"GREENBRIDGE"

RE: Percolation Retesting
Greenbridge Subdivision
Lots 1-5
Greenbridge Road

RE: S-90-16, Greenbridge, Lots 1-5

RE: S-90-016
Greenbridge Lots 1-5
Tax Map: 28 Block: 13, 19 Parcel: 58
Prop. Development: Residential - 5 SFA

A 41160

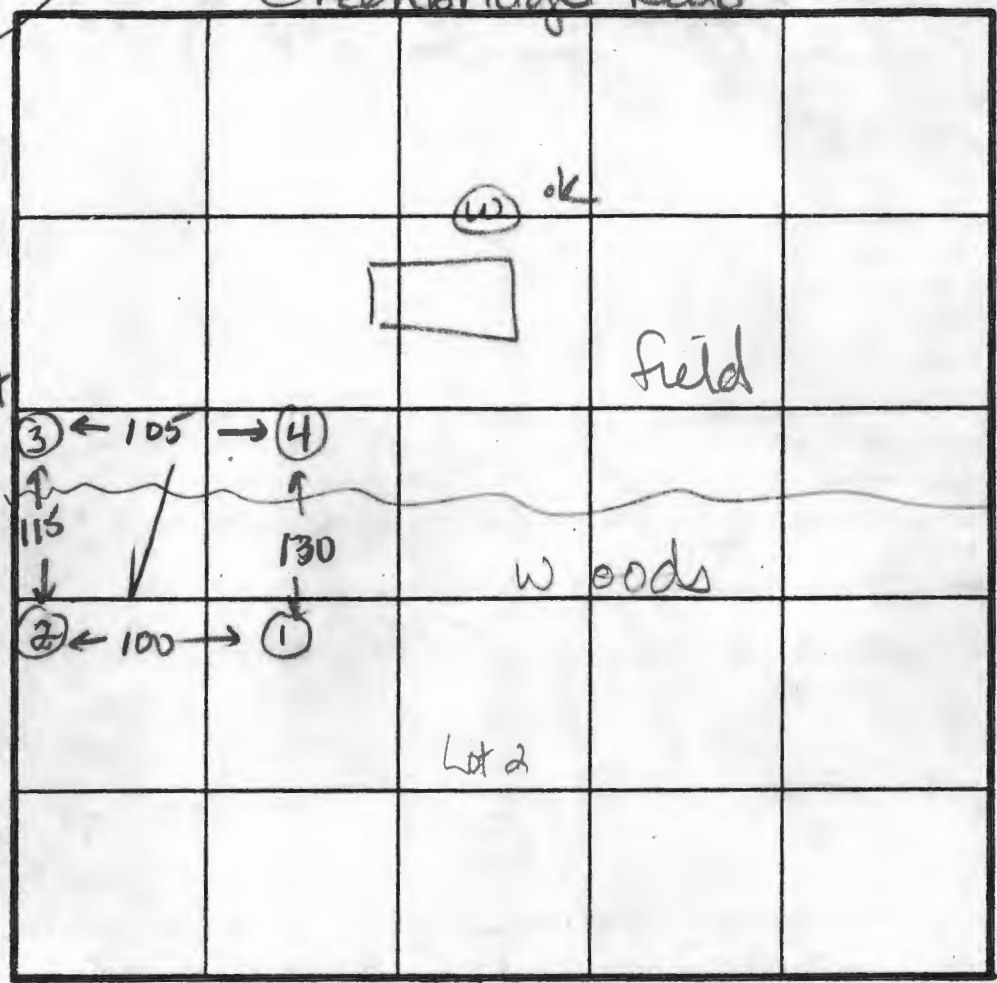
REASONS FOR REJECTION OR HOLDING 6-10-88 Pending perc hole locations and plat approval JEN.

REMARKS All holes as shown on plat.
 TYPE OF SOIL 0-5 Rd-br sil m 5-12 Br mica sa si m, < 20% saprolite
 TESTED BY J.E. Nadeau ALSO PRESENT Carl Duncan

A 41162

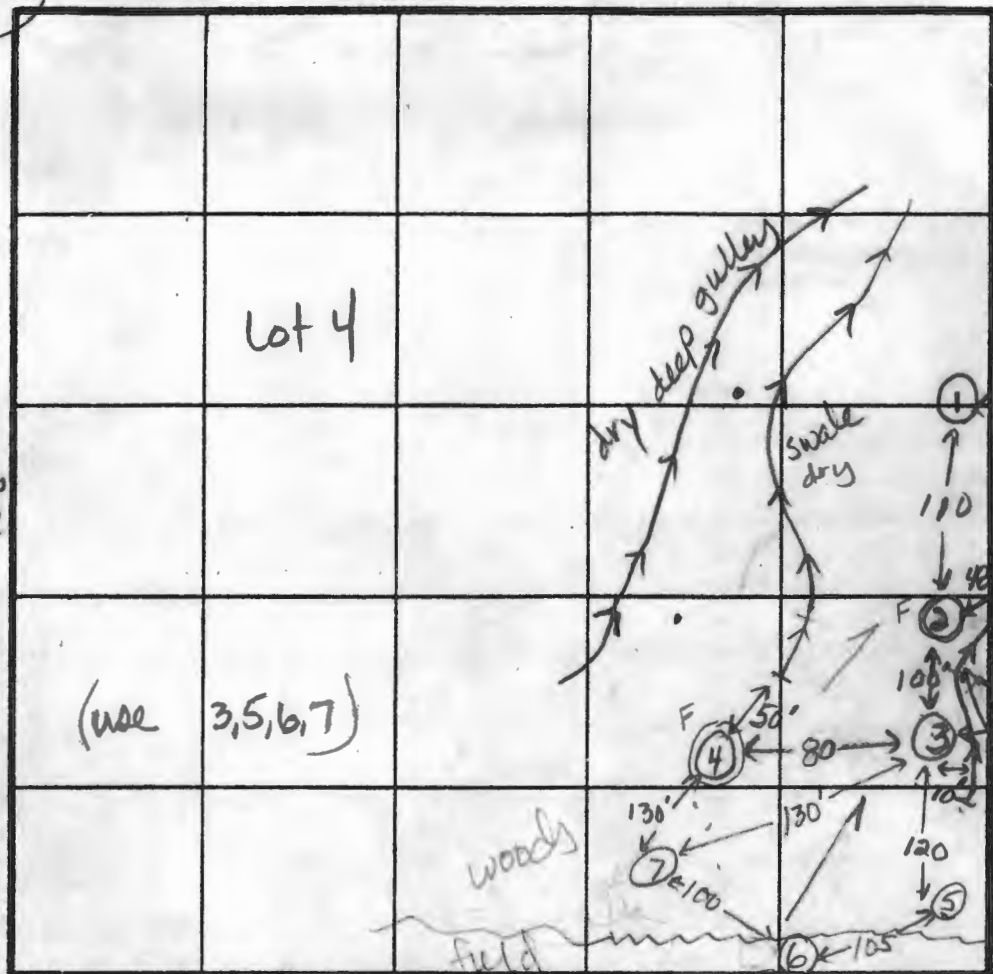
REASONS FOR REJECTION OR HOLDING 5-20-88 Pending perc hole locations and subdivision plat approval, JEN

shallow
system
only,
4-6
ft

REMARKS All holes moved from plat location.

A 41163

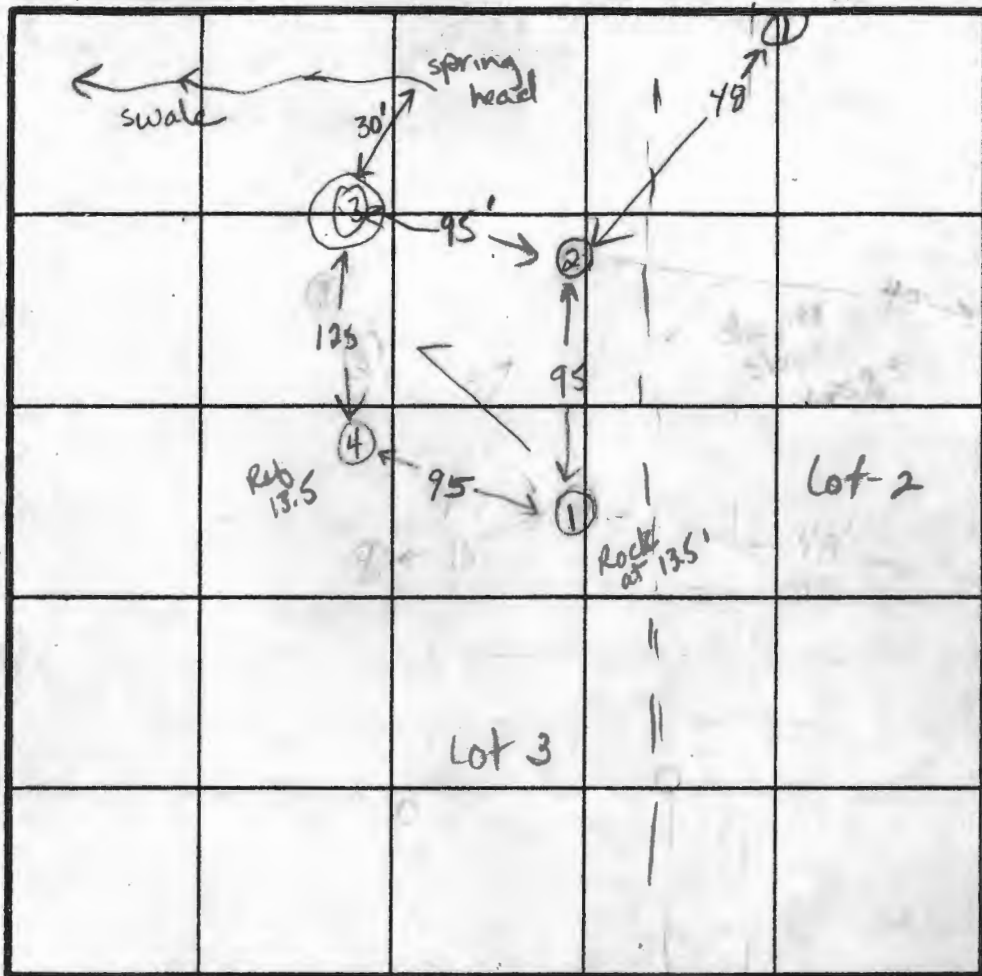
REASONS FOR REJECTION OR HOLDING 8-22-88 Hold for minor sub plat approval and perc hole locations. May not have 10,000 sq ft. OK to move uphill. 20 ft, SHALLOW SYSTEM ONLY. JEN

o Holes to be tested
Greenbridge Sub.
Greenbridge Road
Lots 1-5

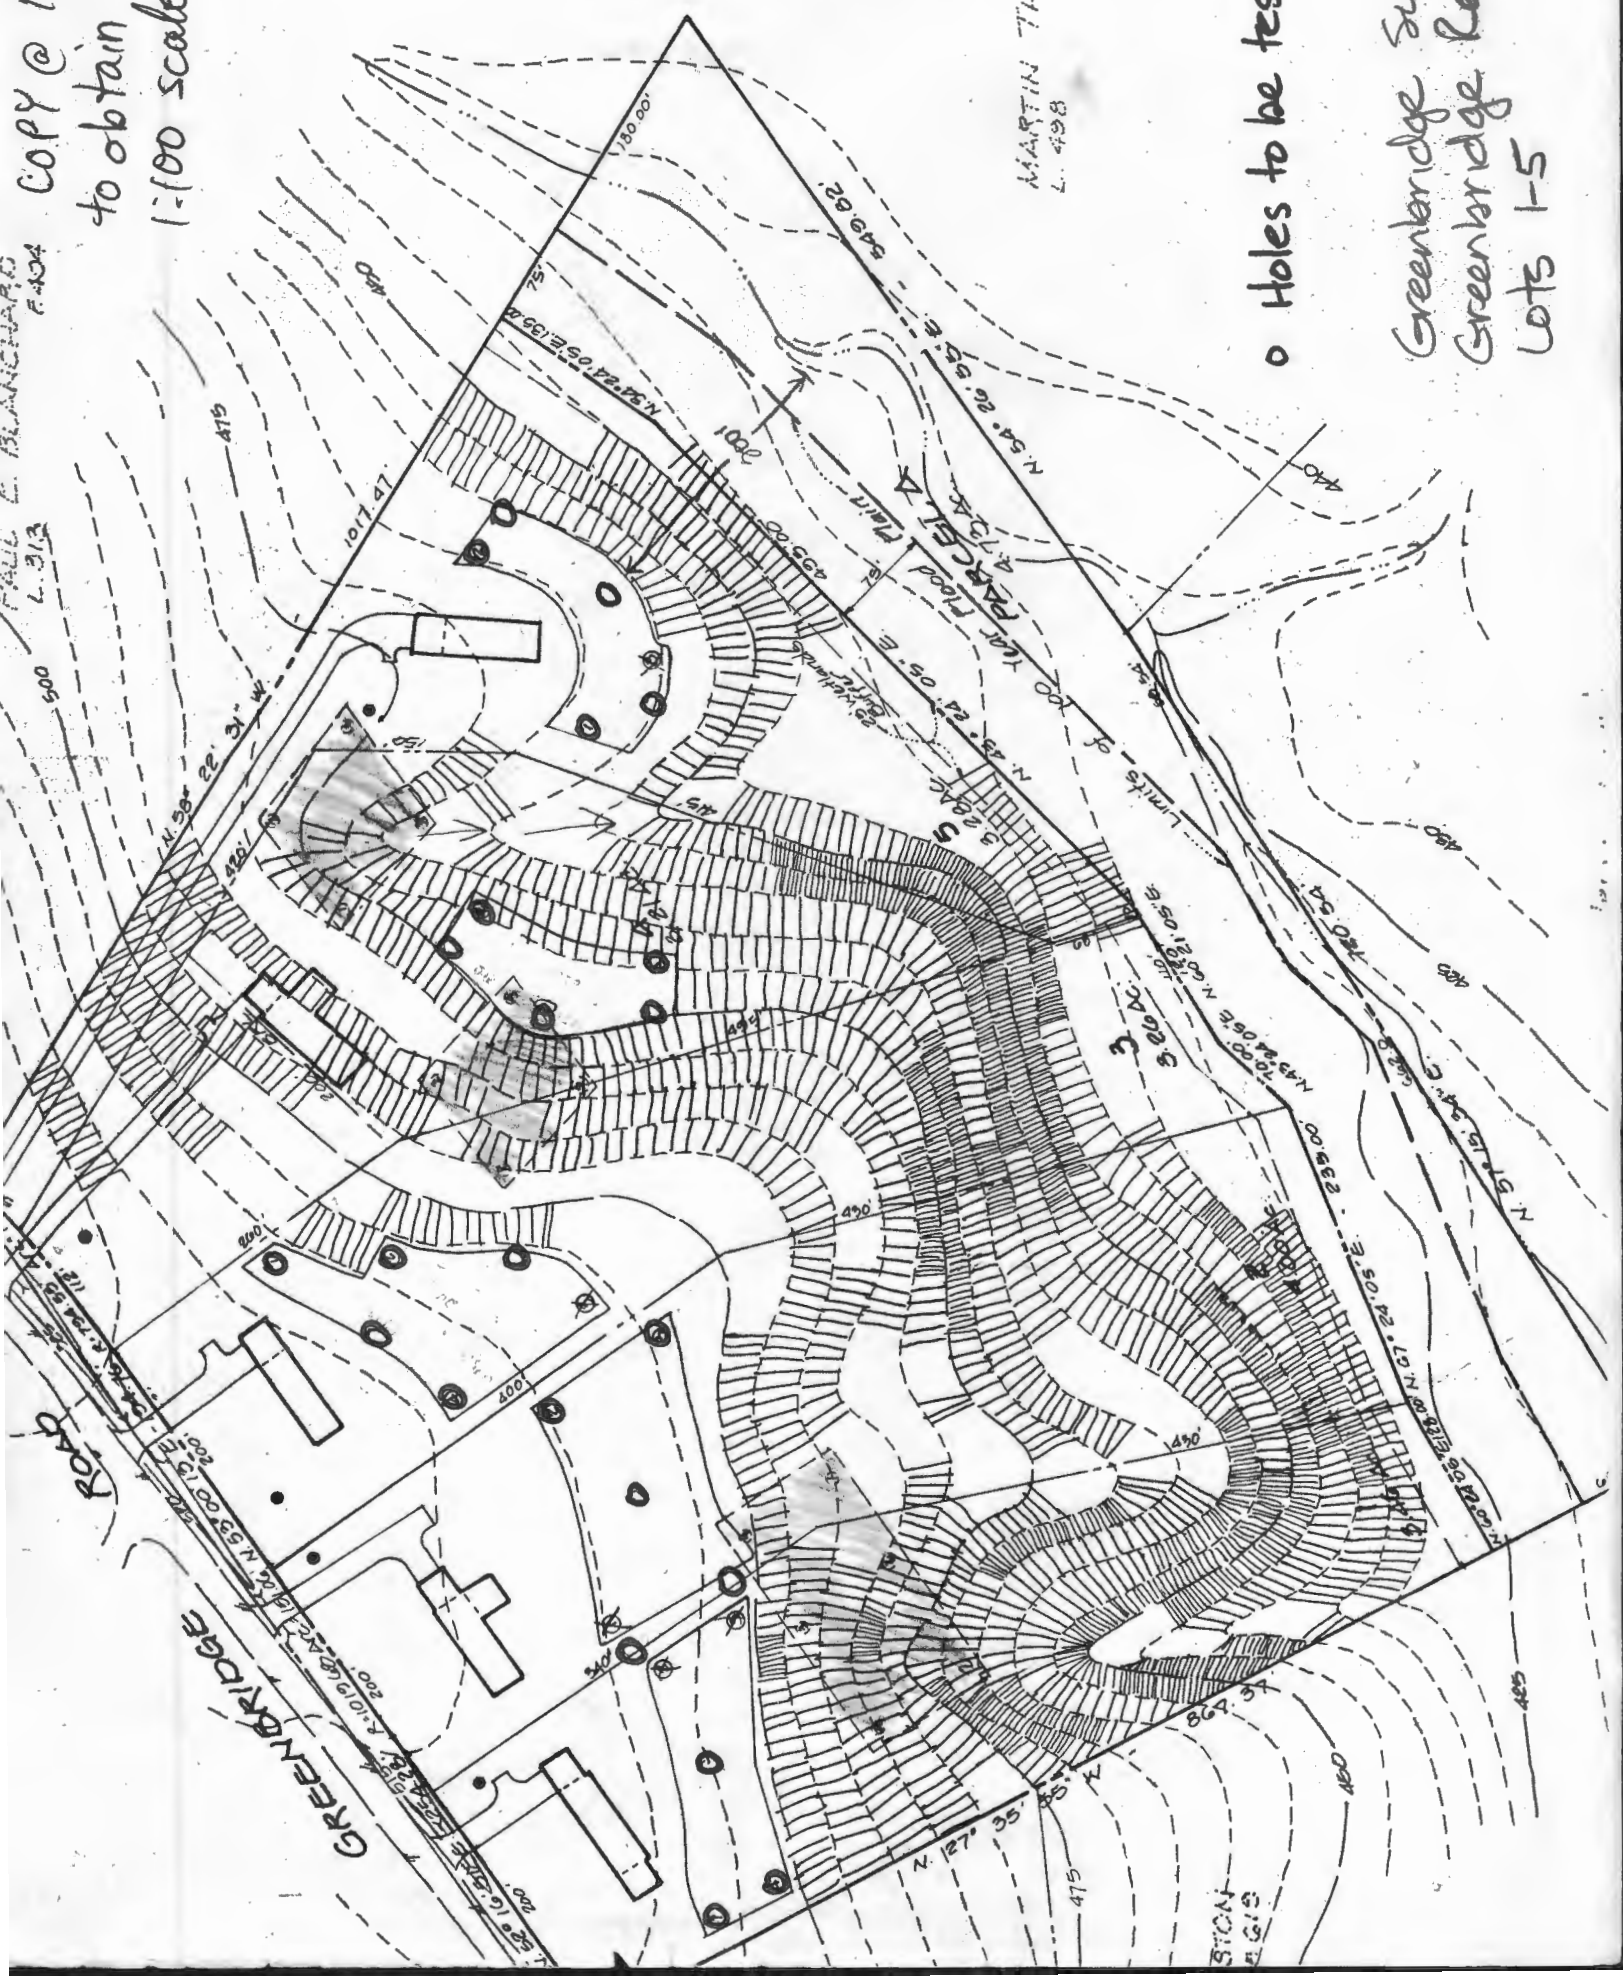
slow loose soil avg 10 min

REMARKS: All holes different from plat (slightly) ONLY SHALLOW SYSTEM
TYPE OF SOIL: 0-4' Br sil cl m, 4-13' Rd-br mica sa sil m, < 30% saprolite
TESTED BY: JE Nadeau ALSO PRESENT: Mr Collins, Carl Duncan, engineer
